SORELL PLANNING AUTHORITY (SPA) AGENDA

5.1 SUBDIVISION APPLICATION NO. 7.2023.18.1

Applicant:	M A Crawford
Proposal:	Three (3) Lot Subdivision
Site Address:	15 Gatehouse Drive, Sorell (CT 39266/6)
Planning Scheme:	Tasmanian Planning Scheme - Sorell
Application Status	Discretionary
Relevant Legislation:	Section 57 of the <i>Land Use Planning and Approvals Act 1993 (LUPAA)</i>
Reason for SPA meeting:	Subdivision creates more than one lot.

Figure 1. - Proposed Subdivision Plan

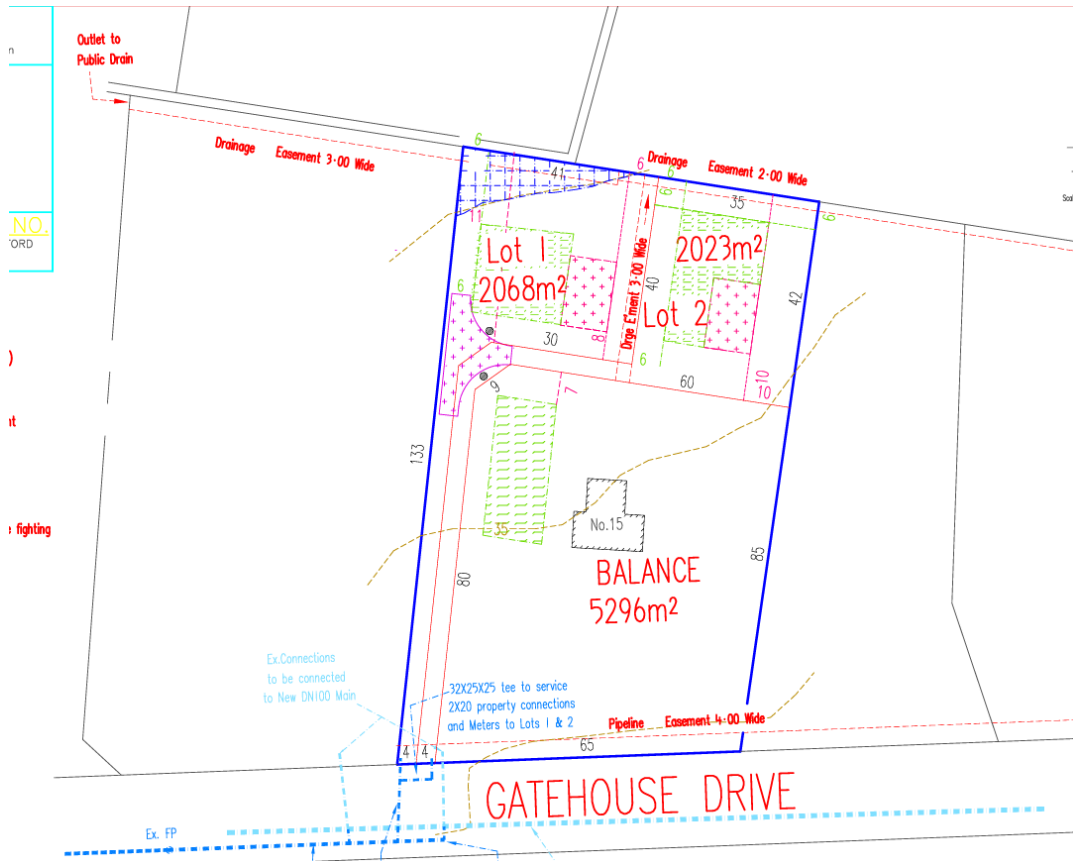
Application is made for a three (3) Lot Subdivision at 15 Gatehouse Drive, Sorell. The subdivision plan consists of the creation of two (2) additional lots with sizes of 2068m² and 2023m² and a balance lot of 5296m² (see the subdivision plan below). The existing dwelling on the balance lot is to be retained with site access from the existing crossover from Gatehouse Drive. Both proposed additional internal rear lots (lots 1 and 2) have access from Gatehouse Drive.

The proposal includes a three metre wide drainage easement for the benefit of the balance lot over lot 1. A stormwater main runs through lots 1 and 2.

Applicable zone standards		
Clause	Matter	Complies with acceptable solution?
10.6.1 A1	Lot Design	Yes, as all lots are greater than 1500sqm in size and able to provide for building envelopes that comply with the prescribed boundary setbacks.
10.6.1 A2	Frontage	No, as frontage for lots 1 and 2 are less than 20m - refer to performance criteria assessment below.

The performance criteria is applicable as lots one (1) and two (2) are internal lots provided access via a shared eight (8) metre Right of Way (ROW). It is considered that the performance criteria is satisfied given that each lot has satisfactory means of access for vehicles as demonstrated by the bushfire hazard report.

Issue	Relevant Clause	Response
<p>There will be an unacceptable increase in additional stormwater resulting from any future development of the additional lots and the risk of an increase in flooding due to existing limited stormwater infrastructure.</p>	<p>Clause 10.6.3 – Services and Clause 12.7.1 – Subdivision within a flood-prone hazard area</p>	<p>The flood prone hazard mapping area is limited to a small north-west corner section of lot one (1). All lots within the plan of subdivision are able to contain a building area, vehicle access, and services that are wholly located outside a flood-prone hazard area. Considering, the proposed subdivision complies with the acceptable relevant solution and by virtue there is no perceived increase in risk of flood for adjacent land.</p> <p>The natural property topography falls away from Gatehouse drive with an existing stormwater drainage easement located to the rear of the lot. Council's officers have assessed the proposal and deemed that the proposed design and existing stormwater infrastructure is acceptable.</p> <p>Downstream stormwater pipes have sufficient design capacity for the 5% AEP event. The downstream stormwater network, however, lacks overland flow paths for 1% AEP events. The proposal has no demonstrable effect on 1% AEP events.</p>

**PLAN OF SUBDIVISION
 MA CRAWFORD
 15 GATEHOUSE DRIVE
 SORELL**

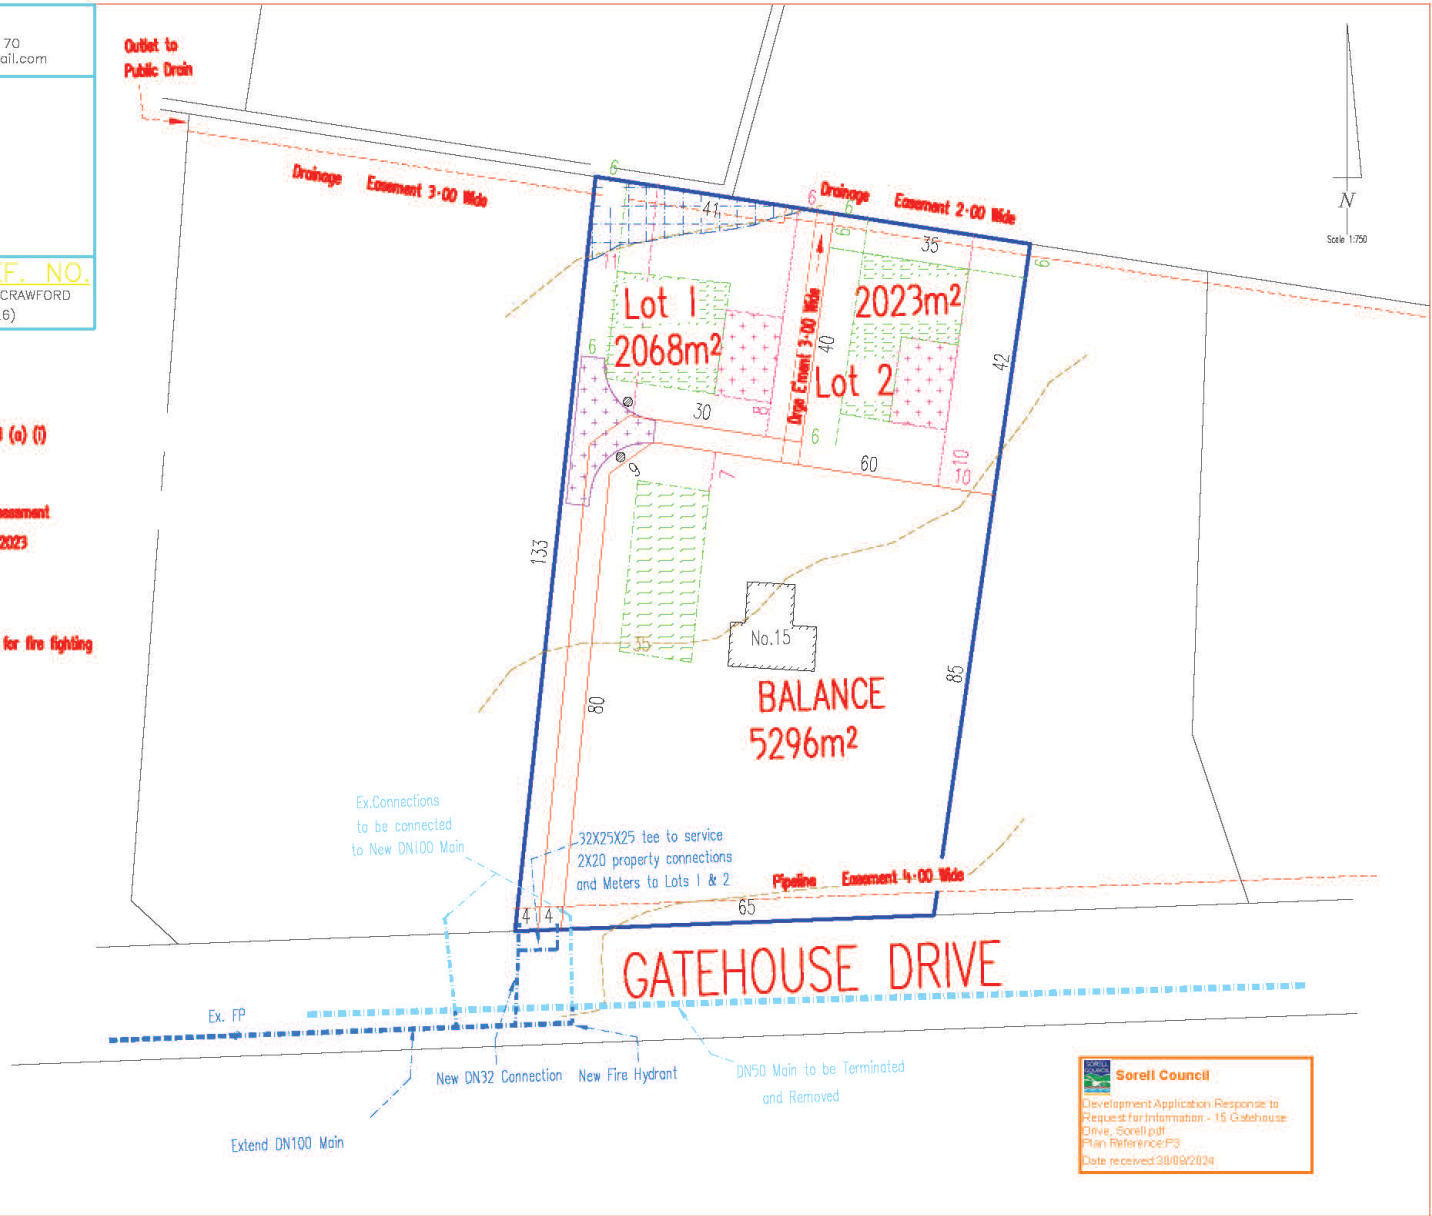
It is my understanding that the two additional lots will be connected to the storm water drain which runs behind Valley View Close and Gatehouse Drive. The storm water system is currently not sufficient to support the current dwellings requirements, and I believe adding two additional lots will cause increased pressure on this system which will have a negative impact on my property.

My property receives run off from the surrounding properties on Gatehouse Drive, Valley View Close and the adjacent hill. This contributes to excessive water build up, it increases the flood risk and undermines the structural integrity of the surface and buildings. During periods of large precipitation, the water run-off is excessive, and the storm water drain can't cope with this as water backs up on my property, adding two further properties is going to increase this issue and heighten the risk of flooding.

The council have already acknowledged that this is known problem and there is a risk of flooding due to the high level of waterflow through the storm water system and adding an additional two properties will significantly increase the runoff to this drain and could subsequently flood the low lining properties at the end of Gatehouse Drive and/or flood my property. I do not believe that the infrastructure is adequate to facilitate the needs associated with another two dwellings.
